Percolation Test Report; 10865 Braeburn Drive, Columbia, MD

Re: Braeburn, Lot 13  
10865 Braeburn Road  
Percolation Certification Plan

Date:	June 28, 2018
Attention:	Hank Oswald
Re:	10865 Braeburn Drive Braeburn, Lot 13 Percolation Certification Plan
Project #:	18-001

### PERCOLATION CERTIFICATION PLAN

### PERCOLATION CERTIFICATION PLAN

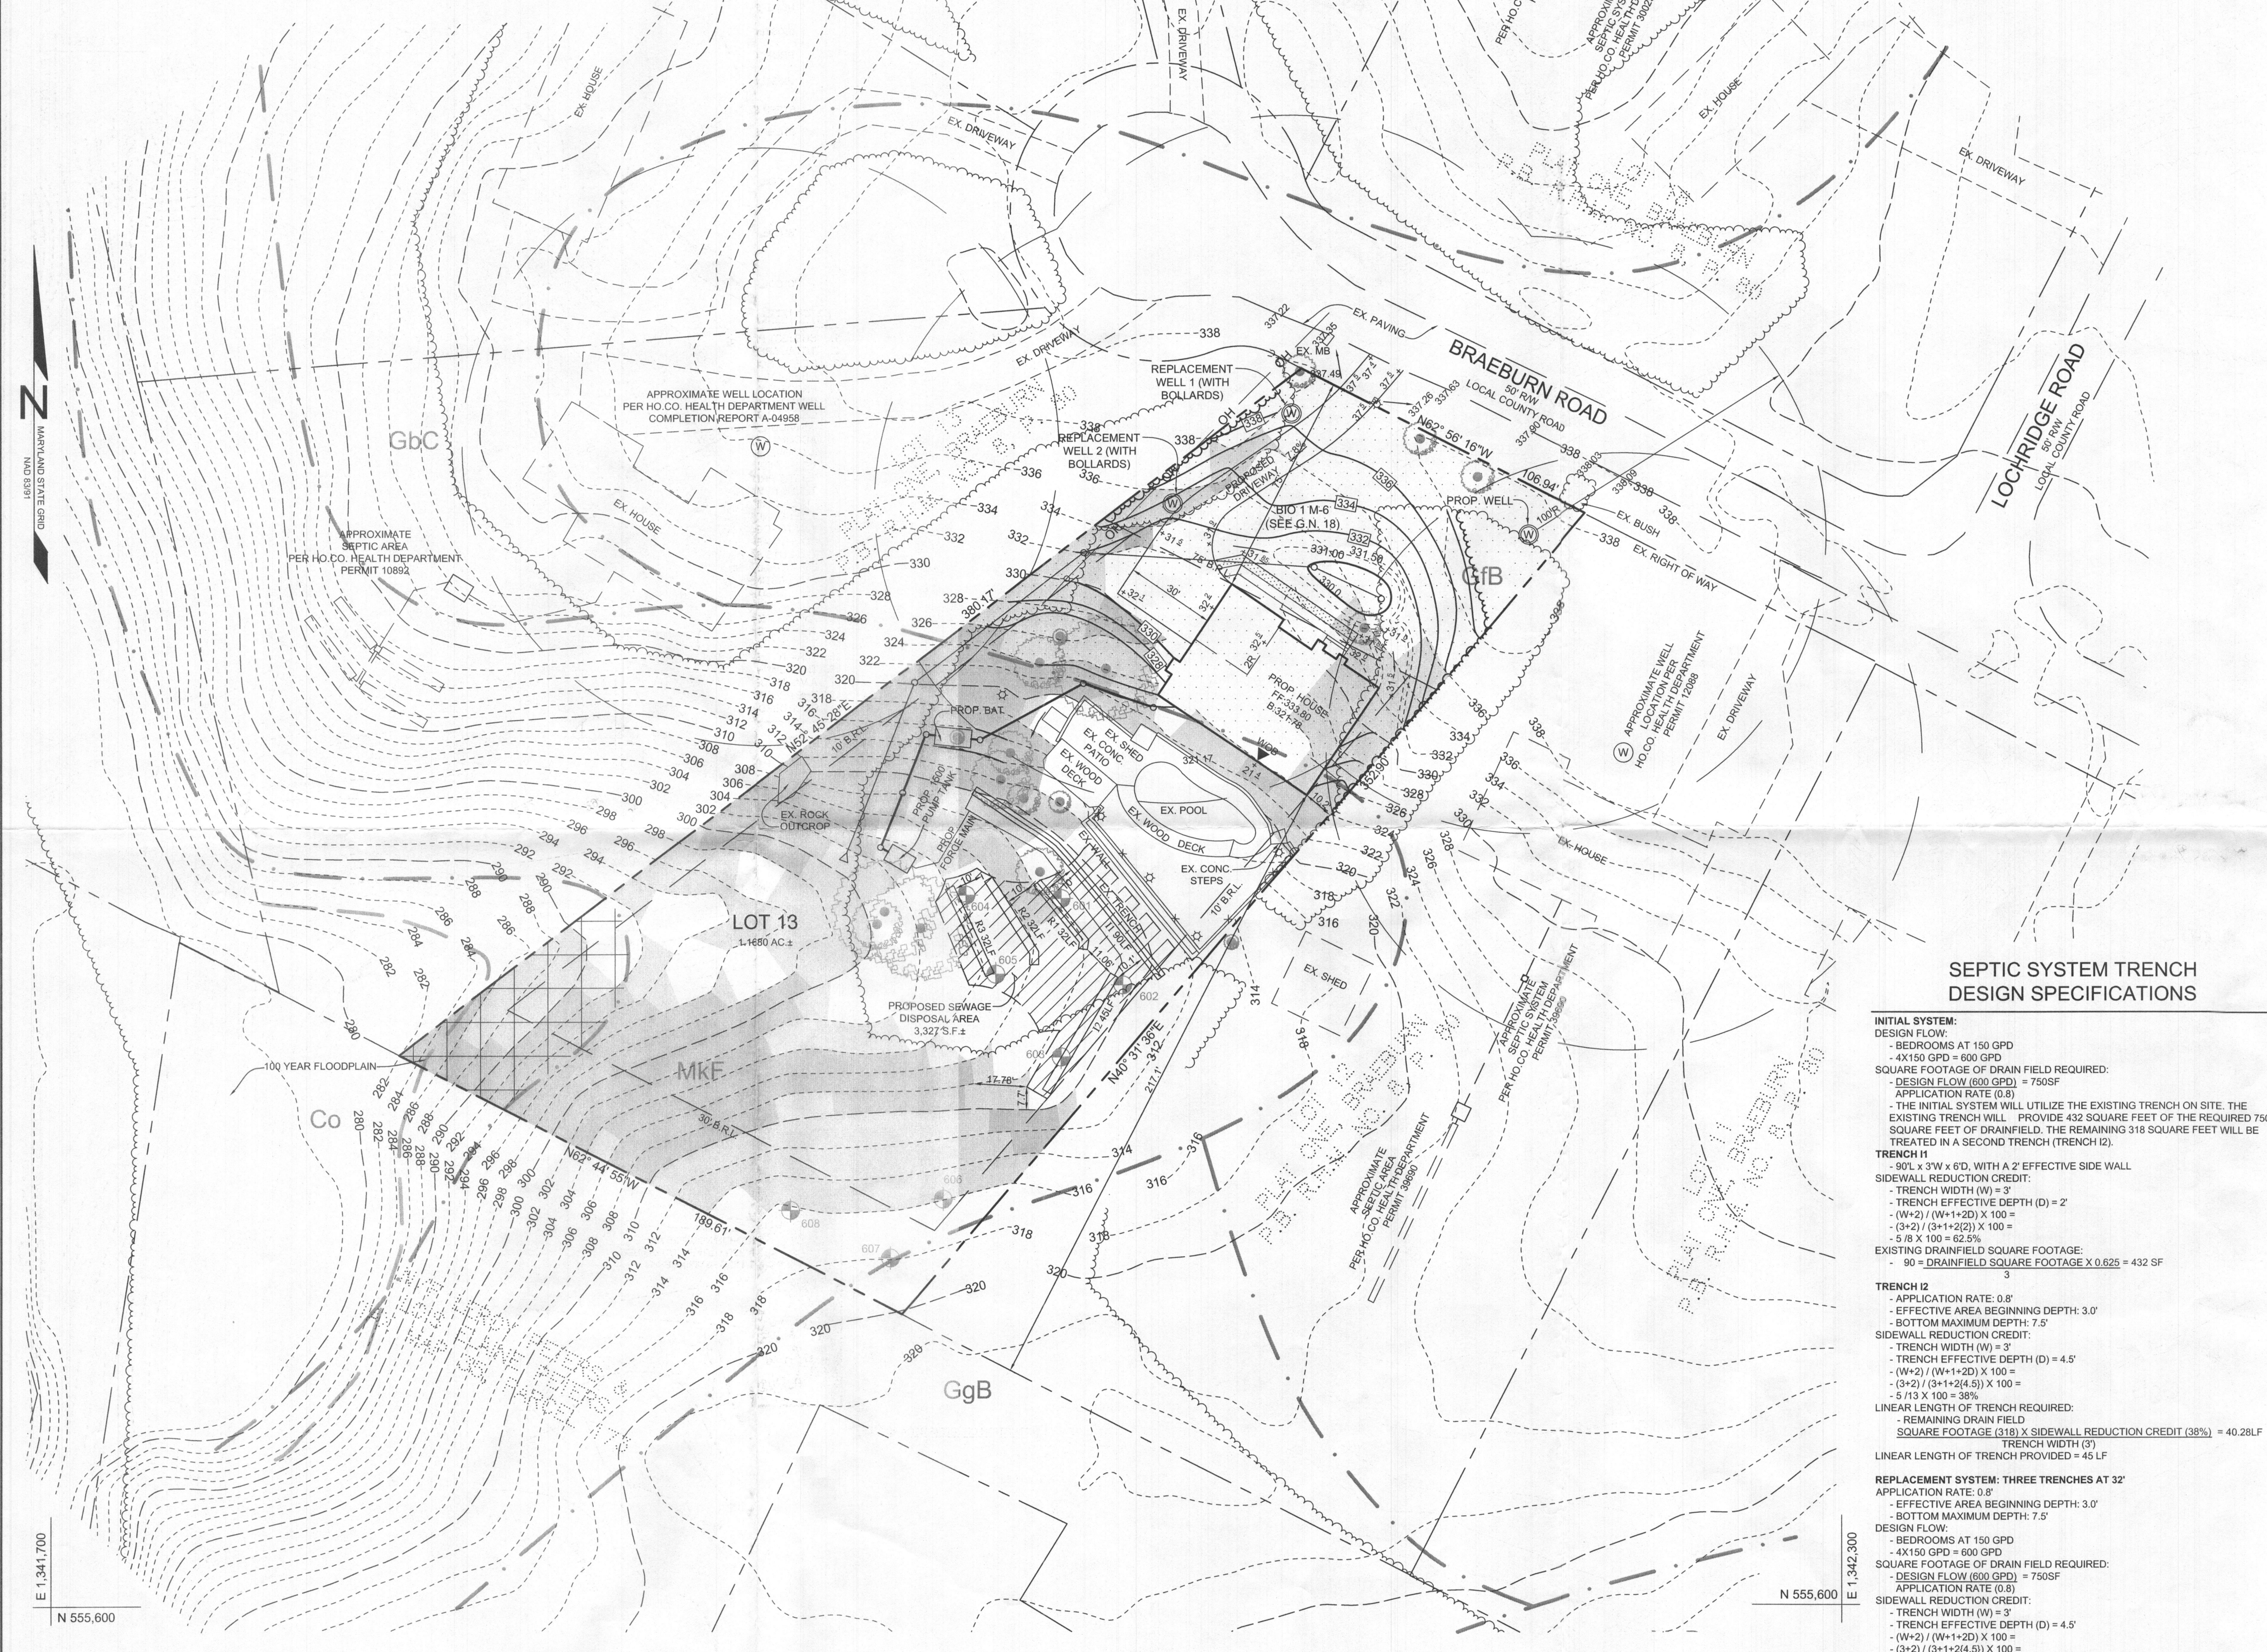
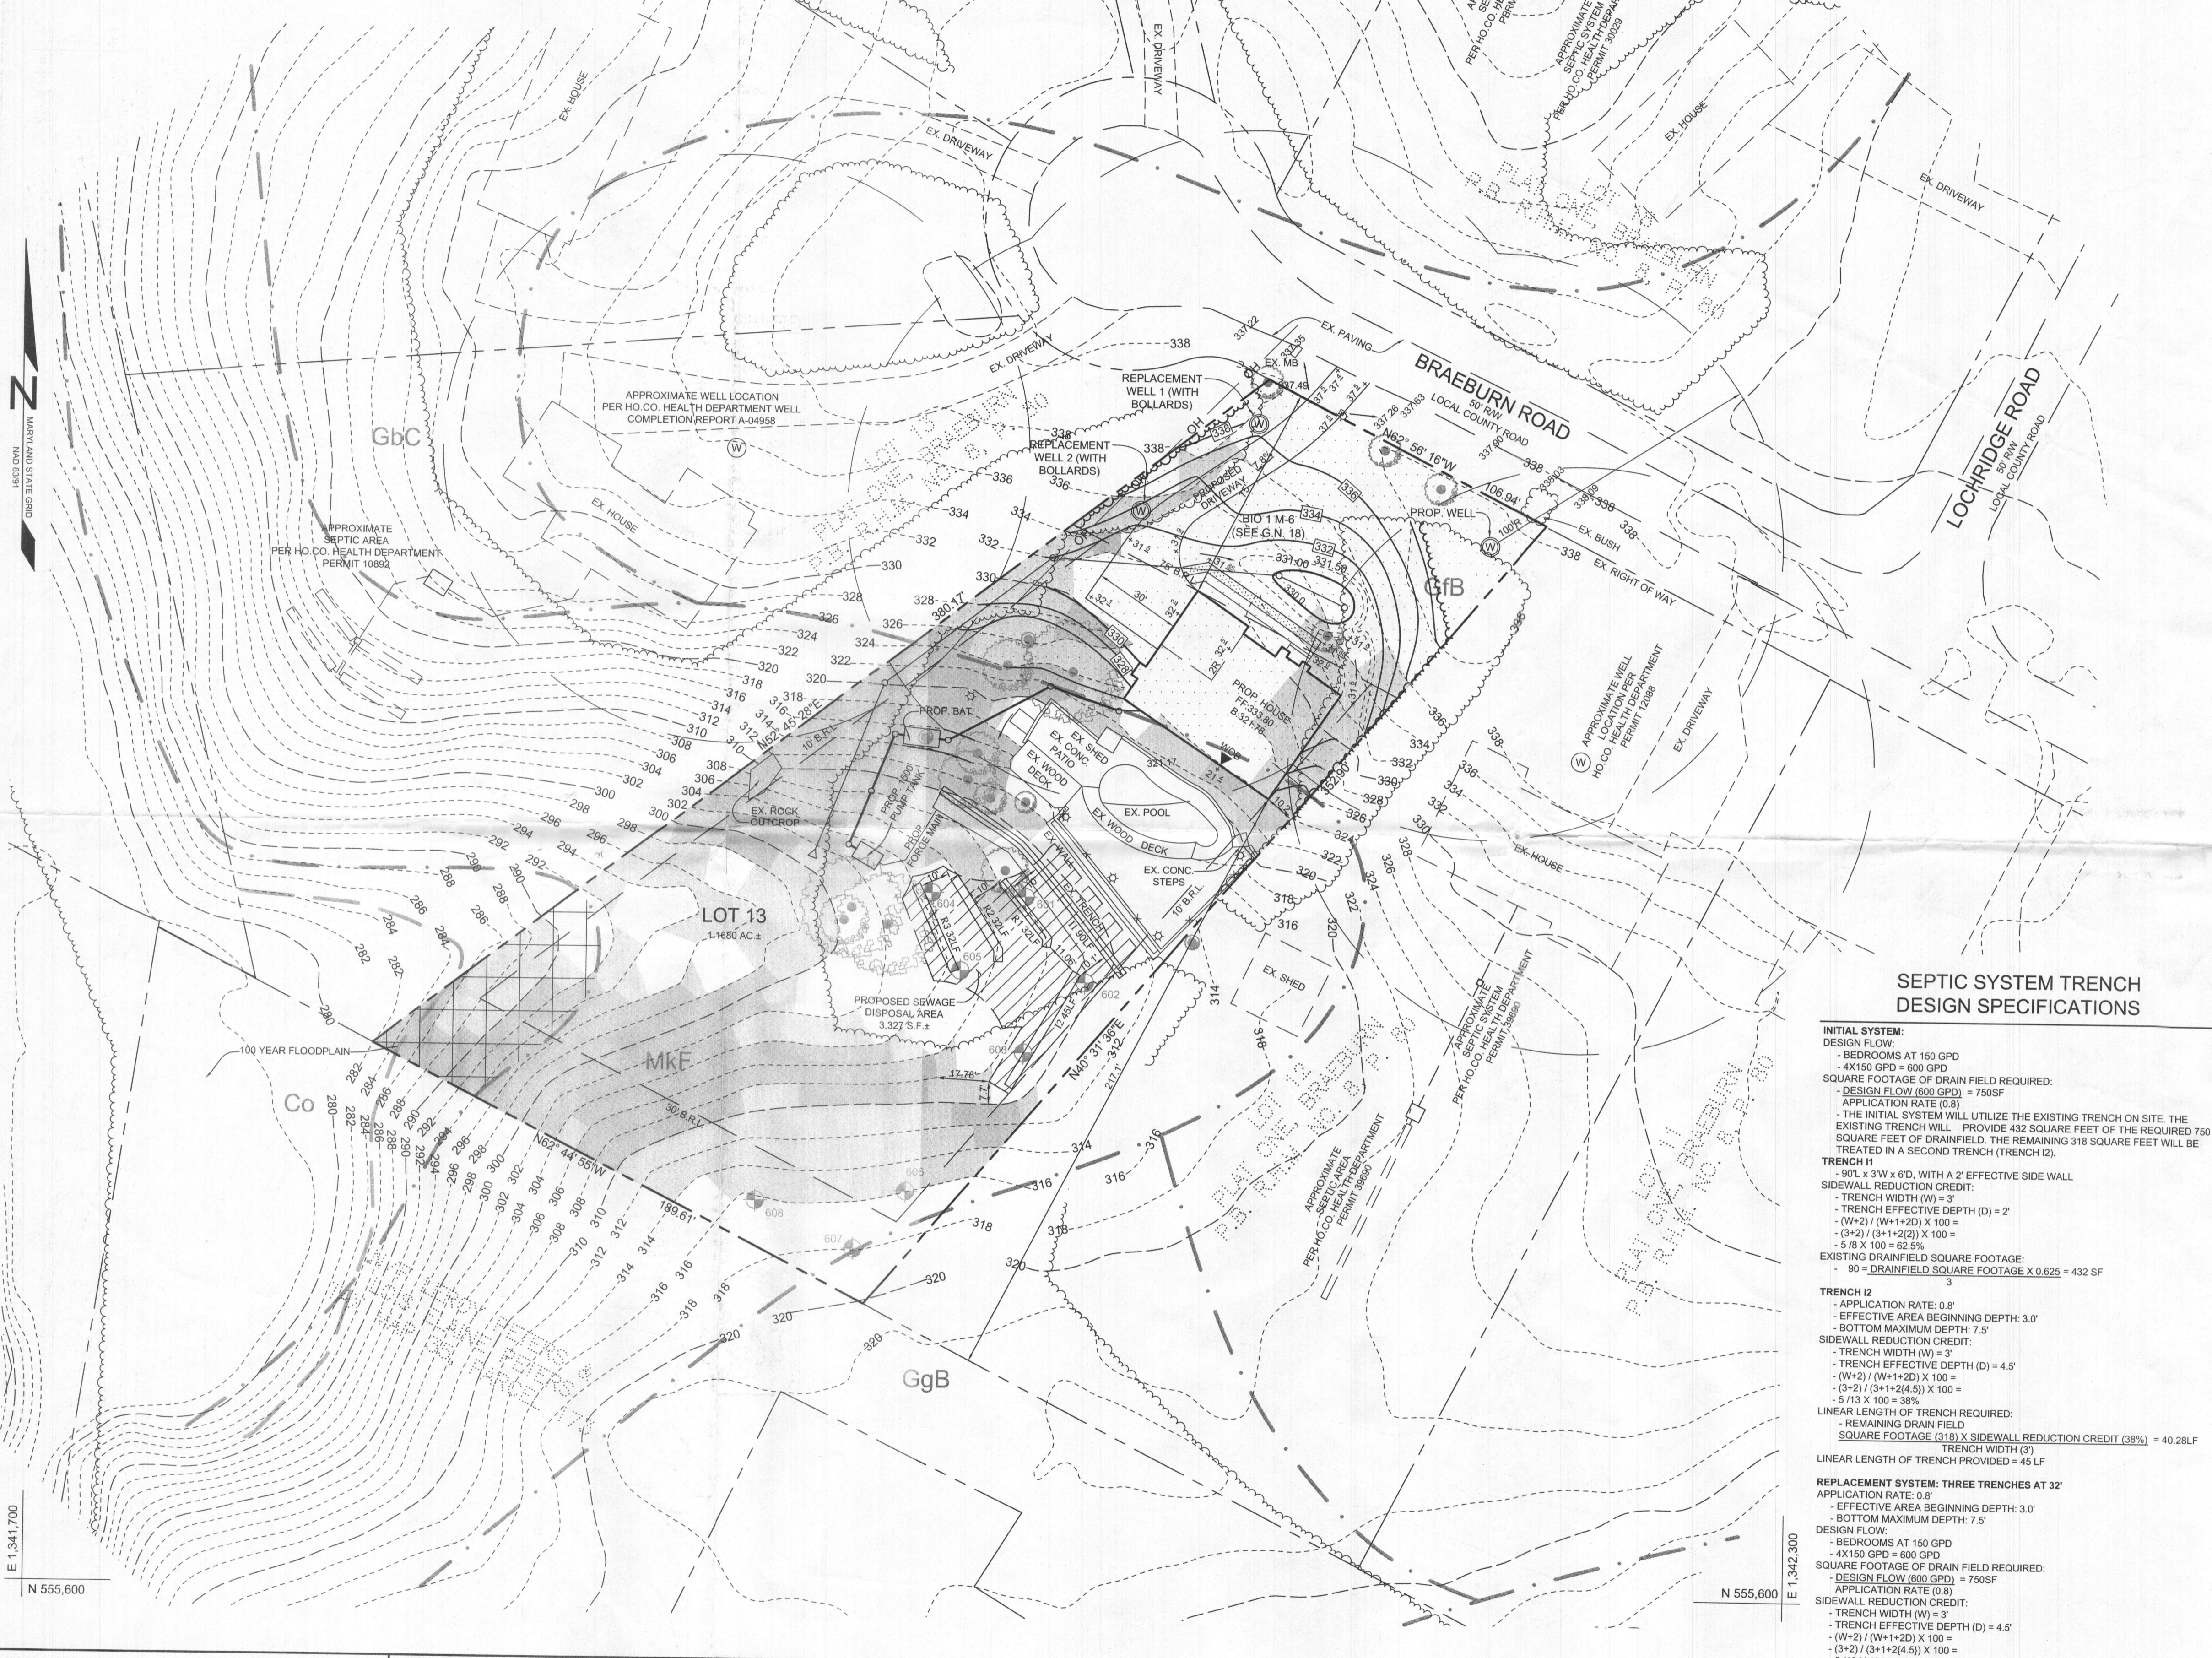
The plan looks good but the DW is within 100 feet of the alternate well site. Move it down the hill as suggested. Any issues, please contact me.

The perc cert plan for 10865 Braeburn Drive was rejected due to the following comments:

1. Show 3<sup>rd</sup> well site along driveway and property line while relocating DW. down the hill.
2. Relocate pump tank so it pumps up to both systems
3. Show neighboring wells and septic systems (See attachments for Lots 12 and 14)

For this project the Howard County development process starts with the recordation of the Percolation Certification Plan. Once approved the Environmental Concept Plan will be submitted to DED for the review of the stormwater obligations. To continue with the development process, we have omitted the designed drywell from the Percolation Certification Plan.

Using MEP for SWM we are proposing to use impermeable liner on the drywell. If you notice General Note 18 was updated to show this. The outfall for the drywell is going the outfall system for the bio-retention facility. We can't move it downhill due to setbacks and steep slopes. I'm considerate of the intention of the setback and think this alternative will support the intention of the regulation.
